HIGHCREST SUBDIVISION, UNIT 1, RESUBDIVISION OF LOT 28

The purpose of this application is to resubdivide one existing lot of record into two lots.

APPLICATION NUMBER 13 DATE May 15, 2008

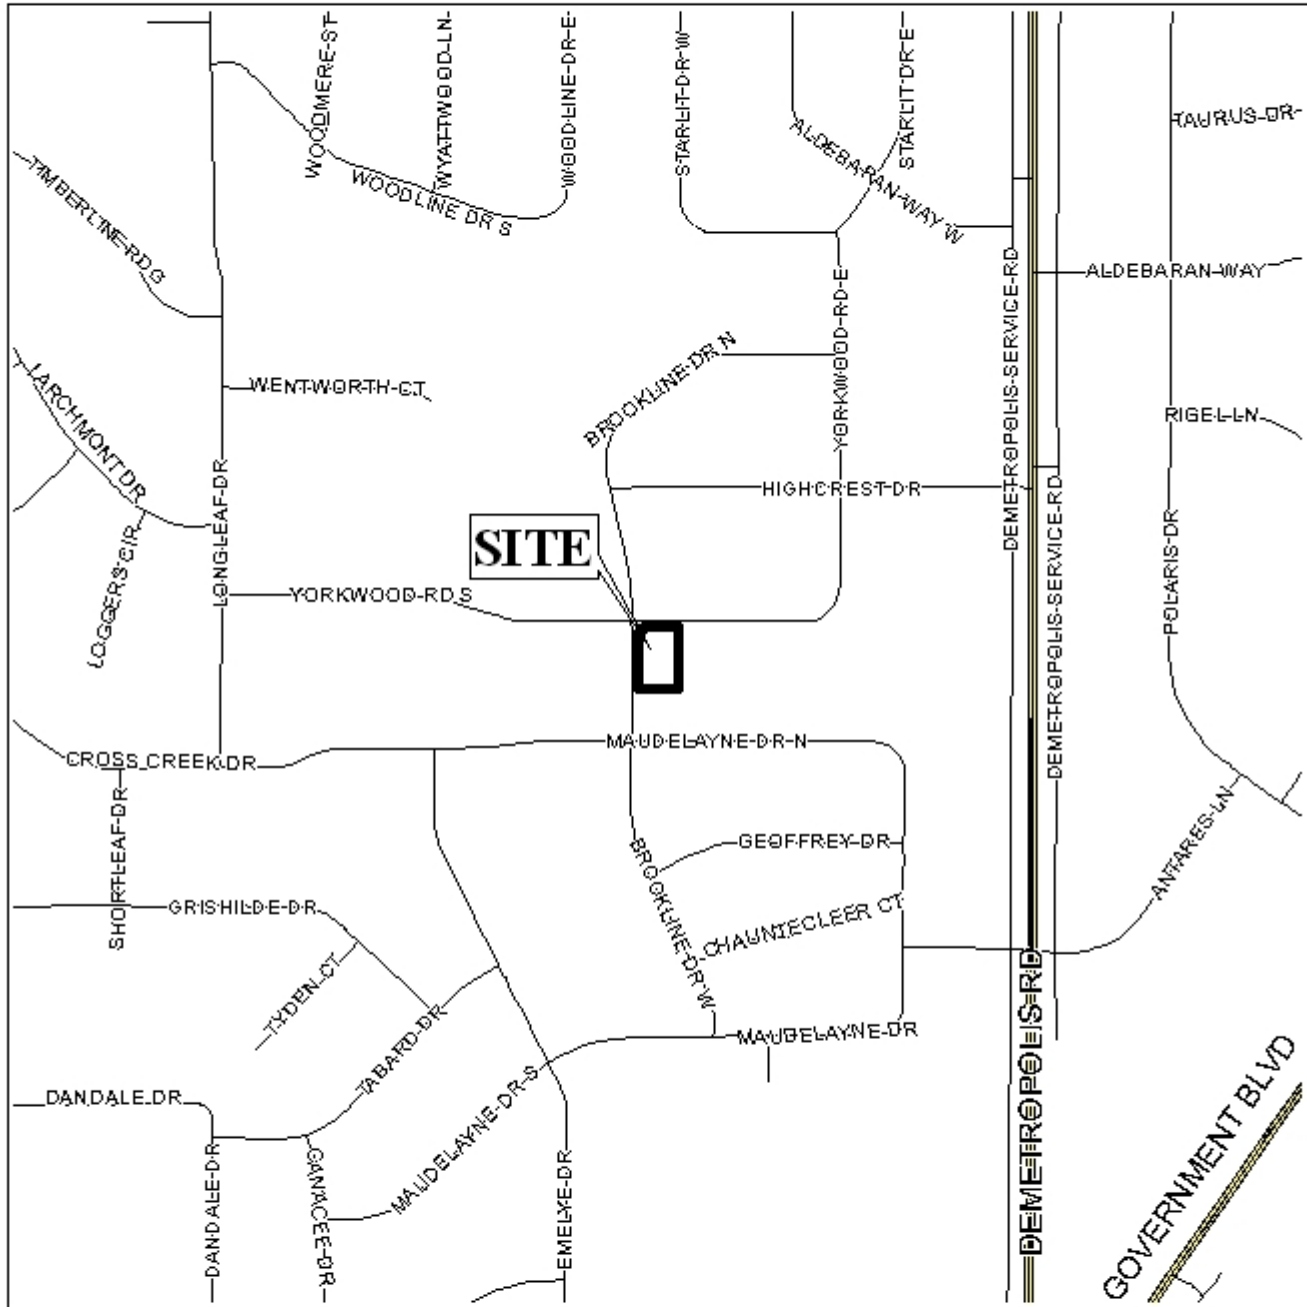
The site fronts on Yorkwood Road South and Brookline Drive West, both of which have an adequate right-of-way width of 50'. The plat illustrates the required 25' minimum building setback line along both street frontages which should also be depicted on the final plat.

Each lot is labeled with its size in square feet, and this should also be done on the final plat, or a table should be provided furnishing the same information. As a means of access management, each lot should be limited to one curb cut with the size, design and location to be approved by Traffic Engineering and conform to AASHTO standards.

City of Mobile GIS aerial photographs taken in 2006 indicate a dwelling on the site which is not indicated on the plat submitted. A review of the GIS map layer does not indicate any dwelling on the site, and none was found in the Planning Section's land use conducted in conjunction with this application. No permit is indicated for the removal of the structure; therefore, an after-the-fact demolition permit should be obtained prior to the signing of the final plat.

1. depiction and labeling of the 25' minimum building setback line as shown on the preliminary plat;
2. labeling of each lot with its size in square feet, or provision of a table on the plat furnishing the same information;

3. placement of a note on the final plat stating that each lot is limited to one curb cut, with the size, design, and location to be approved by Traffic Engineering and conform to AASHTO standards;

5. the obtaining of an after-the-fact demolition permit for the removal of the dwelling prior to the signing of the final plat; and
6. subject to the Engineering Comments: *(Must comply with all storm water and flood control ordinances. Cannot concentrate storm water runoff to an adjacent property without a release agreement or a private drainage easement. Must provide detention for any impervious area added since 1984 in excess of 4,000 square feet. Any work performed in the right of way will require a right of way permit).*
